Relocation and Storage of Isotopic Heat Sources, Hanford Site,
Richland, Washington

DOE/EA-1211

ENVIRONMENTAL ASSESSMENT
FOR THE
RELOCATION AND STORAGE OF
ISOTOPIC HEAT SOURCES
HANFORD SITE
RICHLAND, WASHINGTON
JUNE 1997

Figure 1. Overview of the Proposed Storage Site.

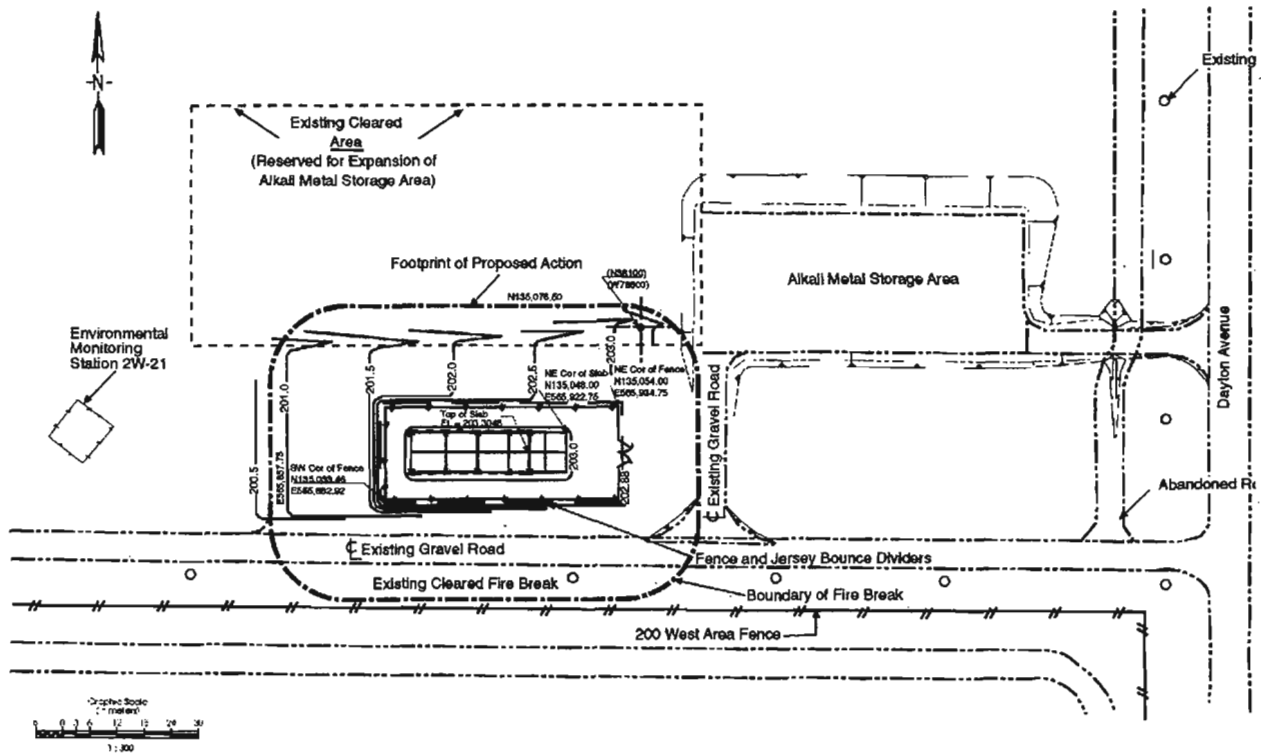
Comment: Figure 1.

This figure depicts the eight storage casks placed on the proposed Storage Pad. It also illustrates that the pad is being over designed for the needs of this action. Please explain this over design flaw.

Response: The storage pad has not been over designed, the storage pad has been sized to support 8 casks containing the isotopic heat sources and two International Standards Organization (ISO) containers and ancillary equipment (e.g., impact limiters, handling equipment) associated with the casks. During storage, the casks would be separated by a minimum of 0.9 meter (3 feet) to allow routine inspections. Additionally, none of casks would be placed within 1.5 meters (5 feet) of the edge of the storage pad. Storage of the casks, ISO containers and equipment would use the entire storage pad. Section 2.0 Description of the Proposed Action has been revised to include the previous discussion. The dimensions for GNS and the CASTOR casks are shown in Table 1. Cask Dimensions and Figure 3.0 has been included showing the layout of the casks, International Standards Organization (ISO) containers and ancillary equipment.

Figure 3. Layout of the GNS and CASTOR Casks, and ISO Containers on the Proposed Storage Site.

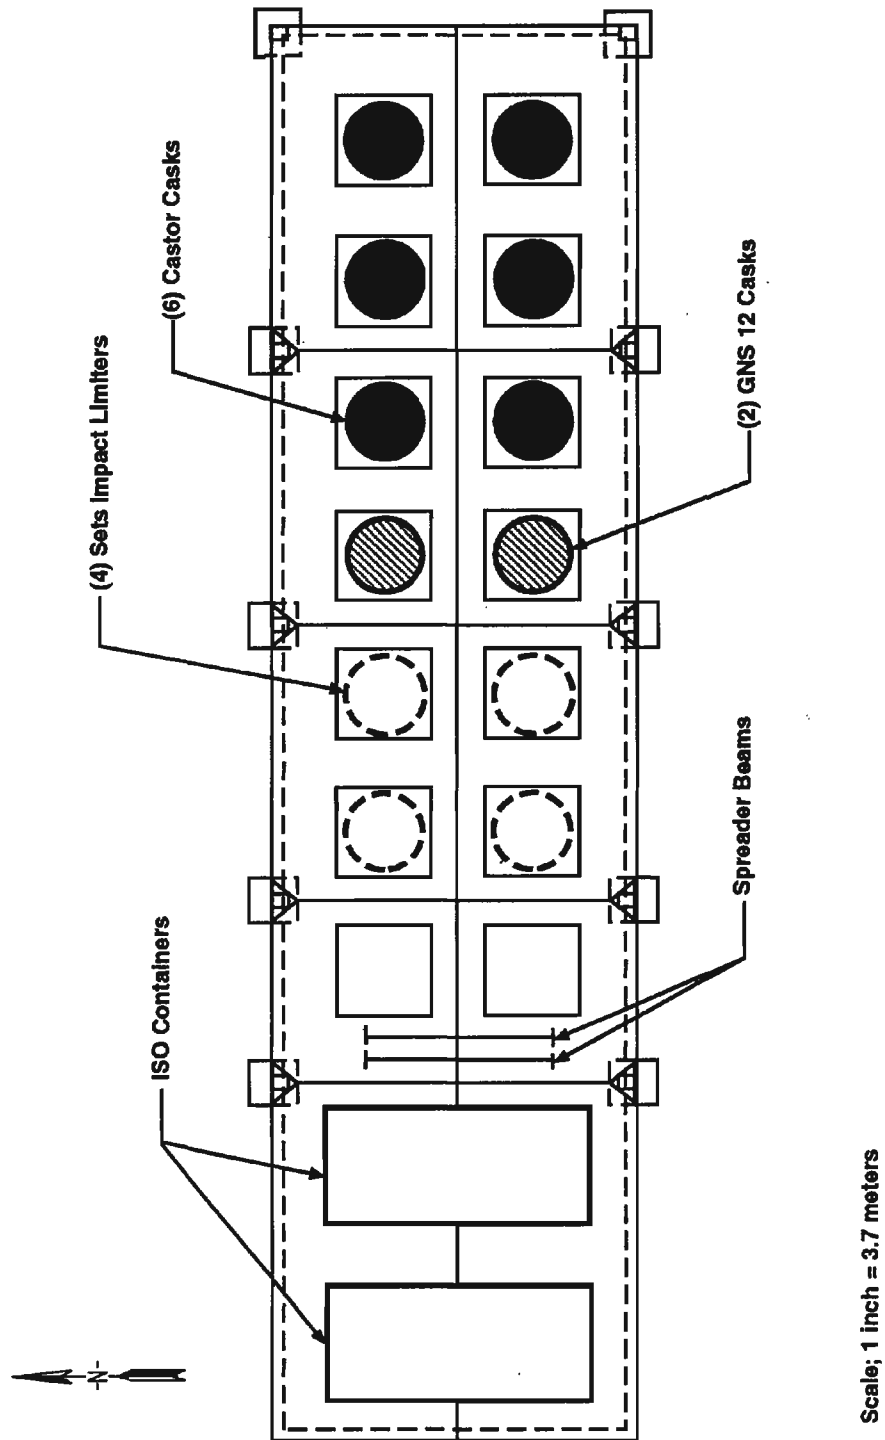
The third paragraph mentions transportation/storage casks will be utilized but author does not provide

dimensions for the casks. Please include the dimensions to assist the reader in justification of the storage pad's length shown in Figure 1.

Response: The storage pad has been designed to support 8 casks containing the isotopic heat sources and two International Standards Organization (ISO) containers and ancillary equipment (e.g., impact limiters, handling equipment) associated with the casks. During storage, the casks would be separated by a minimum of 0.9 meter (3 feet) to allow routine inspections. Additionally, none of casks would be placed within 1.5 meters (5 feet) of the edge of the storage pad. Storage of the casks, ISO containers and equipment would use the entire storage pad.

Section 2.0 Description of the Proposed Action has been revised to include the previous discussion. Additionally, the dimensions for GNS and the CASTOR casks are shown in Table 1. Cask Dimensions and Figure 3.0 has been included showing the layout of the casks, International Standards Organization (ISO) containers and ancillary equipment.
